TURN Comments on the CEC Draft Staff Report
“Incremental Impacts of Energy Efficiency Policy Initiatives Relative to the
Integrated Energy Policy Report Adopted Demand Forecast”
Number 09-IEP-1C “IEPR – Electricity Demand Forecast”

February 25, 2010

I. Introduction

Figure 1: CA Cumulative GWh Savings: 1975- 2005

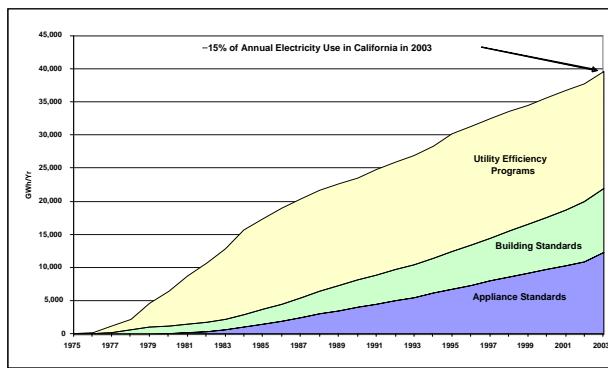
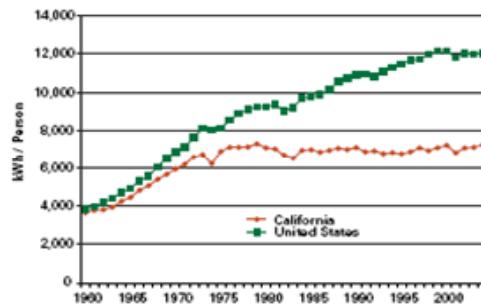
Figures 1 and 2 “CA Cumulative GWh Savings 1975-2005” and “Per Capita Electricity Use in the U.S. and CA: 1960-2004” have received worldwide attention as a putative demonstration that California is possibly “the” leader nationally and internationally in accomplishing what no other country or state has yet to achieve through governmental regulations and policies encouraging EE -- relatively flat per capita electricity consumption.¹

Figure 3
CEC May 2009 Measurement of EE Program Impacts
for the 2009 Preliminary Forecast

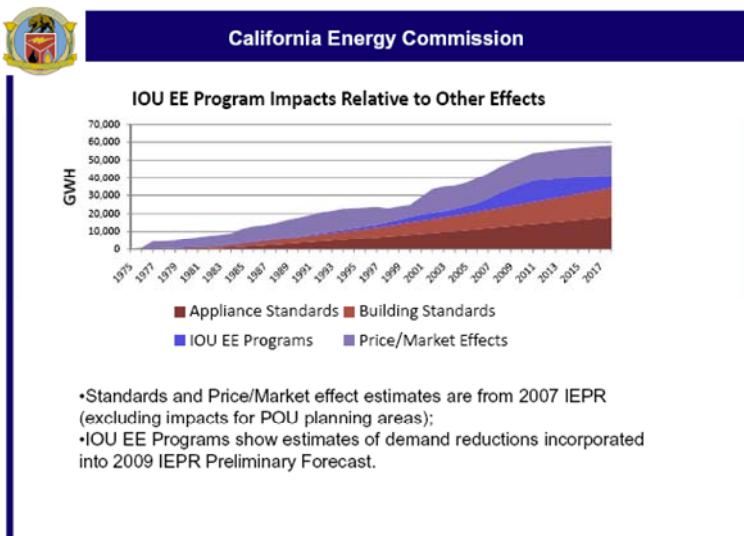
It is important to acknowledge that as part of the process of sorting out committed and uncommitted EE savings in the load forecast the CEC recently issued the following restatement of the historic attribution of EE savings. Per Figure 3, in addition to attributing EE savings to the Figure 1 categories of appliance and building standards and IOU EE programs, the CEC added a fourth attribution category of “price / market effects”² that in effect reassigned the majority of prior classified utility EE program savings to this new attribution category.³

² TURN notes that at least the “price” component of “price / market effects” most likely has more to do with reductions in energy consumption via “conservation” (i.e. just using less energy) than energy efficiency per se (that is, using energy more efficiently).

**Figure 4: Cumulative Savings Data:
EE Programs and Other Savings**

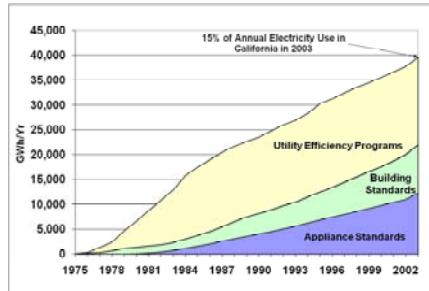
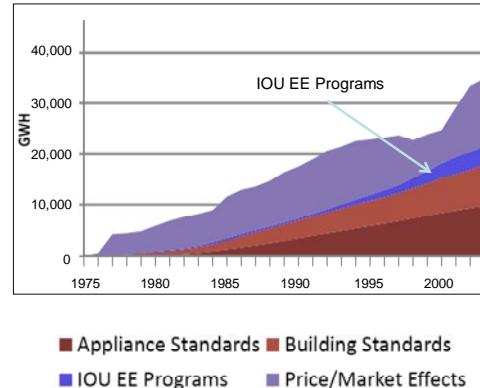
Figure 4 below provides a side-by-side comparison of the CEC's historic attribution of EE savings per the pre-May 2009 or "old series" to the May-2009 or the "new series" 1975 - 2003. The graphs show that per the "old series", fully one-half or 20,000 of the 40,000 GWh in 2003 California cumulative EE savings were attributed to utility EE programs. Per the "new series", 2003 cumulative EE savings are adjusted downward from 40,000 to 35,000, with 20,000 attributed to building and appliance standards. Of the approximate 15,000 GWh of cumulative EE savings, at best only 3,000 GWh are attributed to utility EE programs, with the 12,000 balance attributed to the CEC's new attribution category "price / market effects".

In other words, the new approach correctly recognizes that California's historical track record in EE savings has much less to do with utility EE program savings than previously credited, and much more to do with consumers using less electricity in response to high electricity prices. This is important because the CEC's draft forecast of uncommitted incremental EE savings based on the Itron potential studies is premised on achieving significant utility program EE savings from 2012 through 2020. Table 5 below shows that of the 12,000 GHW of uncommitted incremental EE savings in 2020, over 6,000 or 50+% are attributed to IOU programs, with an additional 2,000 GWh to the CPUC's "Big Bold" Initiatives, which the utilities are integral in making happen.

Figure 7: PG&E Recorded and Projected Savings v. Commission Adopted Goals MW

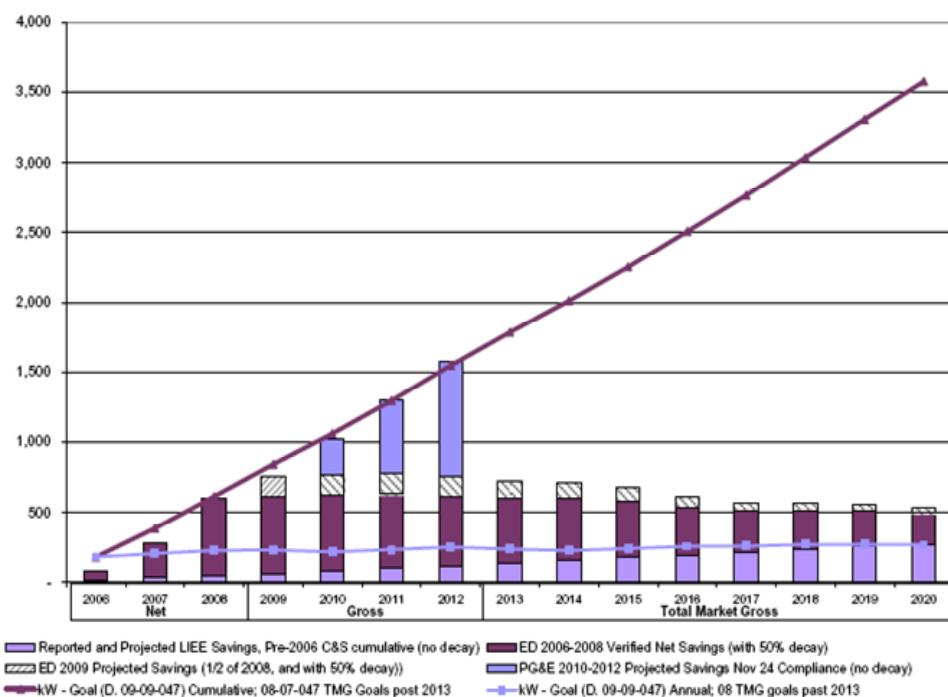
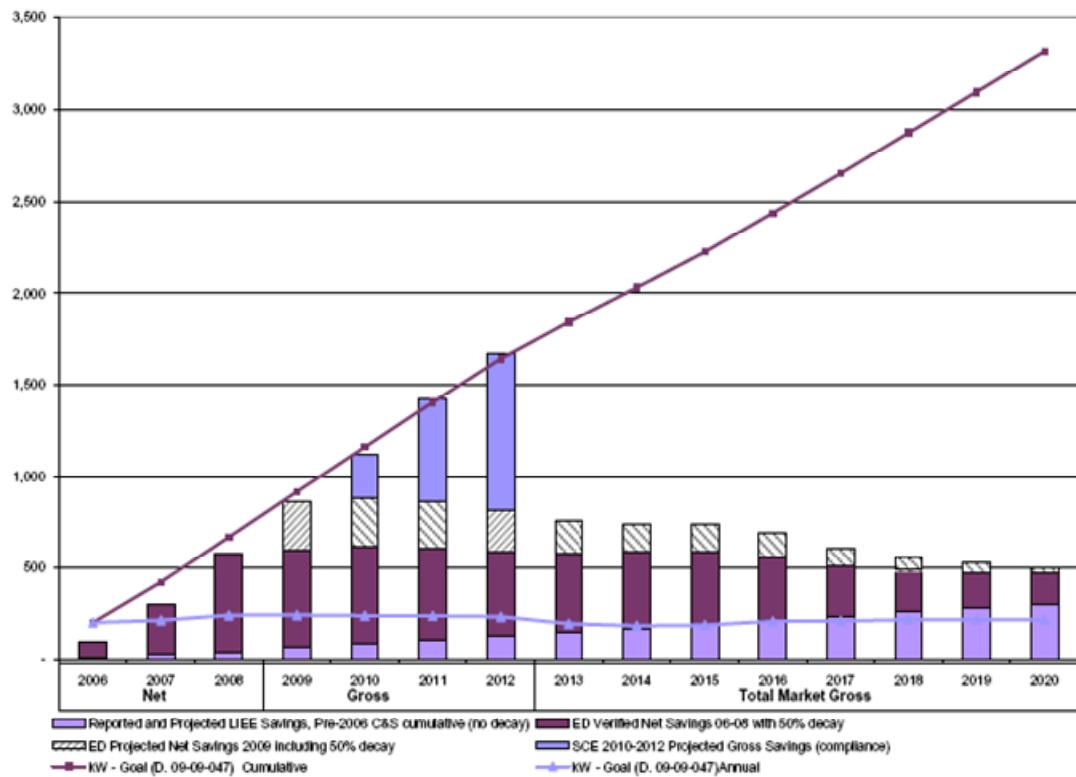
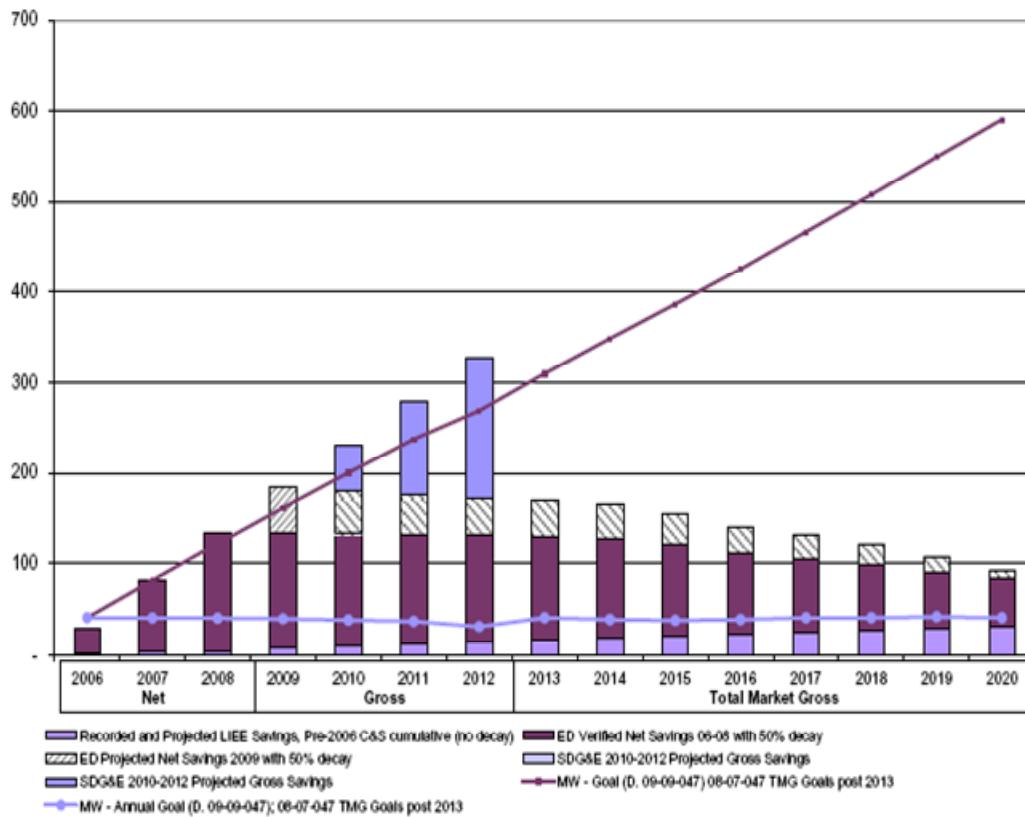
The CEC Report, beginning at Attachment B-9, shows the IOUs' 2010 – 2012 EE savings as forecasted relative to the goals. At the February 17th workshops, Carmen Best, ED, stated "that there was very little cushion in these utility projected EE savings relative to the EE goals". Figures 7 and 8 showing PG&E and SCE recorded and projected savings (2006 – 2012) and the Commission adopted goals in MW peak demand (2012- 2020) illustrate this point.

Similar data for SDG&E in Figure 9 shows that SDG&E's forecasted 2010-2012 savings provide for a modest cushion of savings shortfall relative to the 2013-2020 EE goals. As noted above in discussing Figure 6, if the 2006-2009 EE savings are per Figures 7 through 9 adjusted downward even further, and if adjustments are made to the IOUs projected /unadjusted 2010 – 2012 EE savings to more reasonably reflect similarity of program design and CPUC Energy Division measured and verified results, Figures 7 and 8 for PG&E and SCE would reflect a shortfall or gap between committed (2006-2012) and uncommitted (2013-2020) savings. Figure 9 for SDG&E would most likely indicate elimination of the current modest cushion if not shortfalls similar to PG&E and SCE.

Figure 10: Statewide Non-Coincident Peak Demand 1990-2020

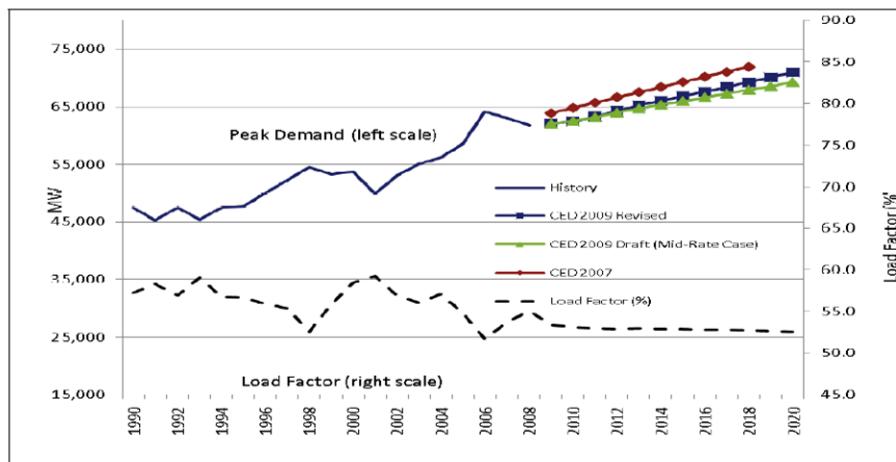
Figure 10 illustrates how California's steady increase in non-coincident peak demand relative to GWh energy requirements has resulted in a steadily eroding system load factor.

Figure 11: PG&E Historic Load Factors 1970-2004

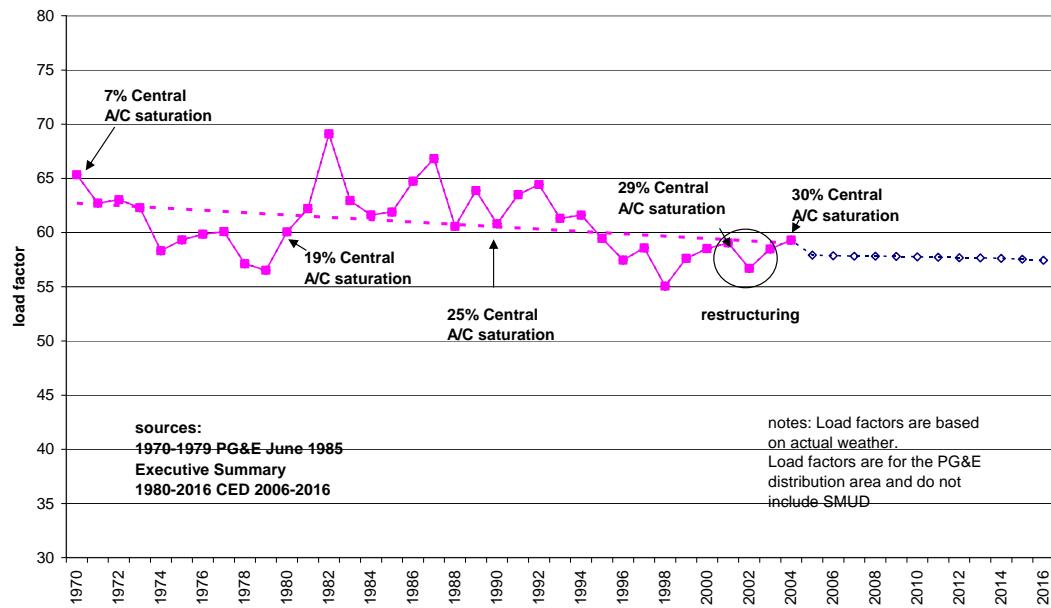
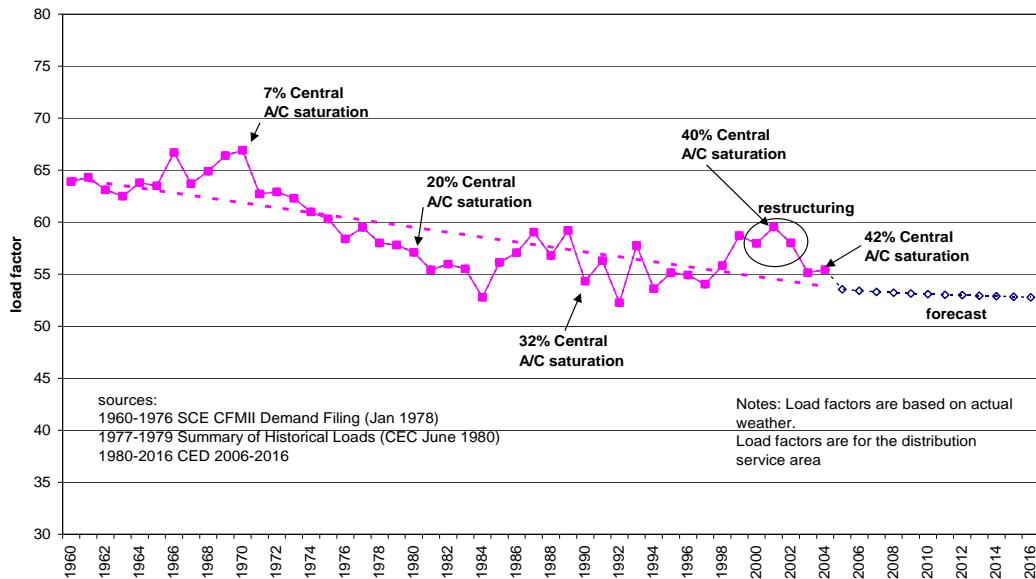
Figures 11 and 12 provide the historic load factors for PG&E and SCE 1970 – 2004 with tracking of growth of the residential central air conditioning saturation over time.⁶ The data shows that as utility system load factors have deteriorated over time (about 65 to 60% 1970 to

2002 PG&E and SCE) residential central air conditioning has increased from 7% to 30% (for PG&E) and 40% (for SCE). For the reasons detailed in this section and our discussion in the prior section of how the recent CEC changes to the historic attribution of EE savings should temper any forecast of utility-EE savings, TURN recommends that it is more prudent to go forward in the LTPP with the lower case scenario (that is higher forecast, lower EE savings).

Figure 13: Total CA electricity consumption 1960-2005 & an AB32-derived trajectory through 2050

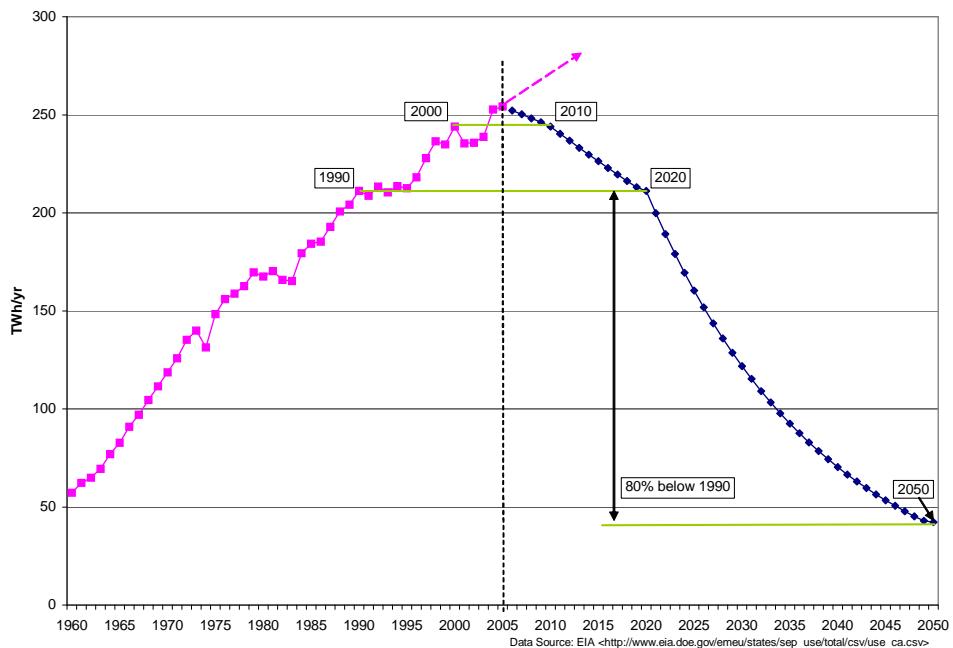
Figure 13⁷ illustrates the magnitude of the task ahead of California in complying with AB 32.

Figure 3: Comparison of evaluated and claimed gross energy savings

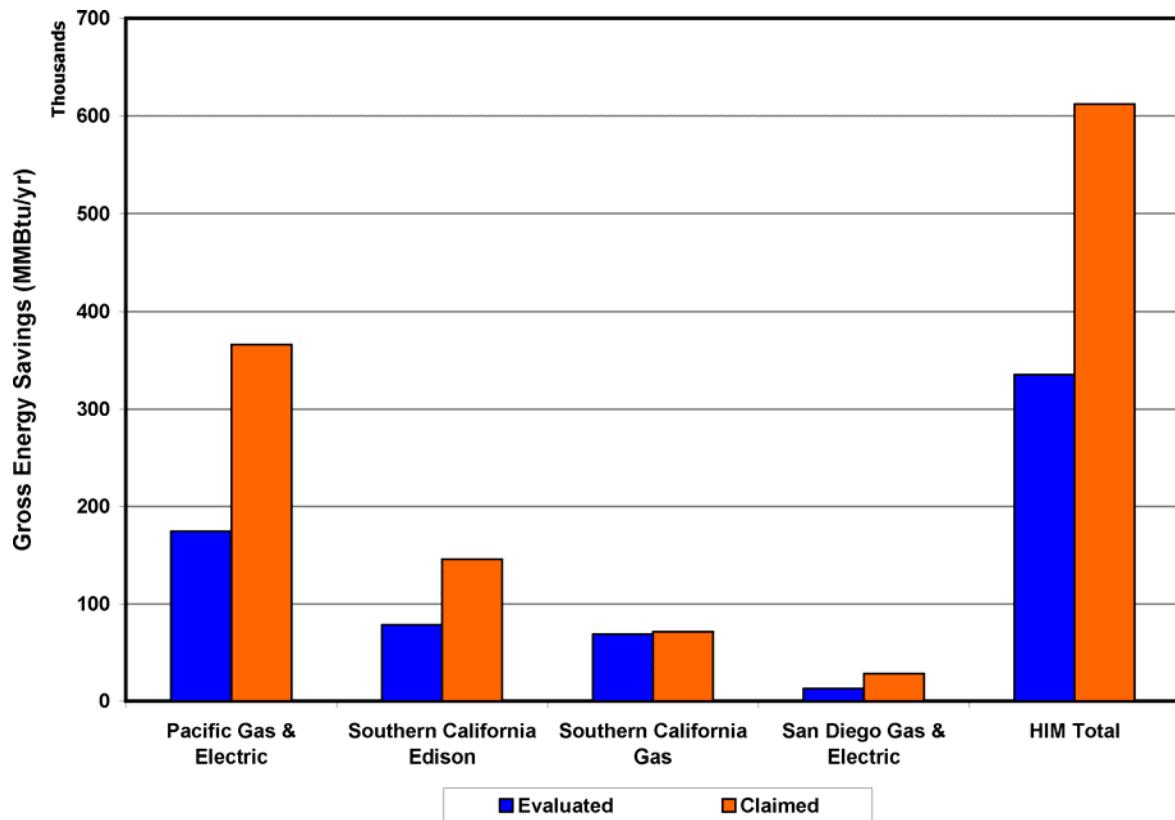
TURN did not include adjustments to claimed savings based on the Retro-Commissioning evaluation in the original analysis. This was because the data are not presented in a useful format. The Retro-Commissioning (RCx) report presents many detailed findings, but there is no summary table providing information on gross and net claimed savings. There are detailed tables with gross claimed savings and gross and net evaluated savings, but the figures in these tables do not seem compatible with those in the rest of the report. The report does present

the figure below, which shows that gross evaluated savings were about 50%-60% of gross claimed savings. The IOUs' E3 calculators show that RCx programs generally were assigned ex-ante NTGRs of 0.8-1.0. The evaluated NTGRs are mostly in this range. In the table below we have applied a NTGR of 0.8 to the gross savings claims to get an estimate of net claimed savings. We then took the net evaluated savings and compared them with our estimate of net claimed savings to generate the % difference data:
